Sub Regional RTEP Committee PJM West

May 22, 2020

ATSI Transmission Zone: Baseline

B2753.9: Remove/Open Kammer 345/138 kV transformer #301

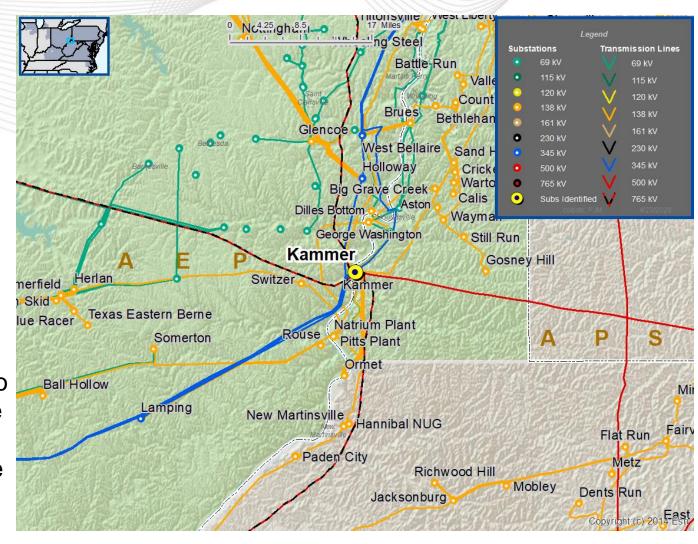
Old Required IS Date: 5/31/2020 New Required IS Date: 9/13/2021

Reasons for the Required IS Date Change:

Opening of Kammer 345-138kV transformer 301 is to address overdutied breakers at Kammer 138kV. Due to the withdrawn queue of Y3-068, re-studied shows the breakers are overduty only after AB2-093, whose IS date is 9/13/2021.

AEP Transmission Zone: Baseline Holston Circuit Switcher Installation

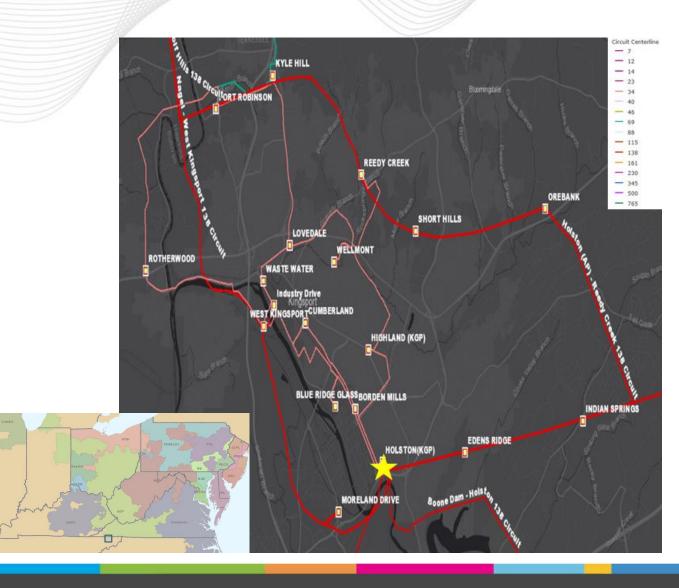
Old Scope: Install a 138 kV 3000A 40 kA circuit switcher on the high side of the existing 138/34.5 kV transformer #5 at Holston station.

New Scope: Install a 138 kV 3000A 40 kA circuit switcher on the high side of the existing 138/34.5 kV transformer #5 and a 138 kV 3000A 40 kA circuit switcher transformer #7 at Holston station.

Reason for change: Transformer 7 serves distribution customers but is located in a Transmission station. After investigating the cost responsibility for the switcher installation with Distribution, the cost should be assigned to Transmission.
